INSPECTION REPORT
Sedimentation Structure
WW-9C
Black Mesa Mine
Navajo County, Arizona
for
PEABODY COAL COMPANY

Dames & Moore
10139-011-22

Structure WW-9C was inspected on August 30, 1985 by an interdisciplinary team of engineers from Dames & Moore. The purpose of the inspection was to assess the safety and general condition of the structure with respect to United States Department of Interior, Office of Surface Mining (OSM) regulations.

SITE PLAN
WW-9C

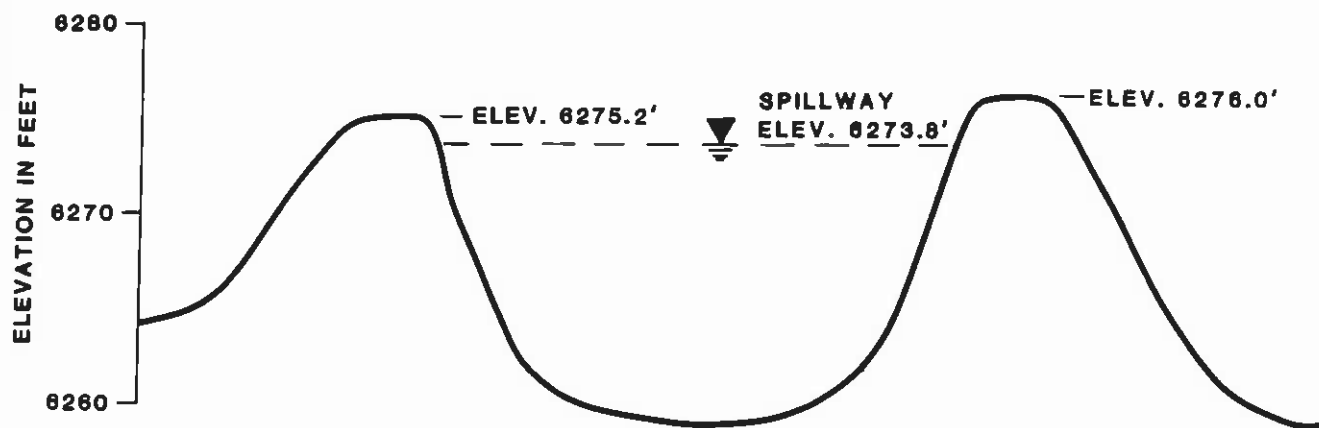
The storage capacity and spillway capacity of Structure WW-9C are adequate; however, the spillway does not have an adequate outflow channel or adequate erosion protection. A trapezoidal outflow channel should be constructed along the alignment B-B' shown in Plate 1. The channel profile is shown in Plate 4 and the required dimensions are shown in Plate 5. Both the spillway and outflow channel should be protected against erosion using geotextile and gravel as shown in Plate 5.
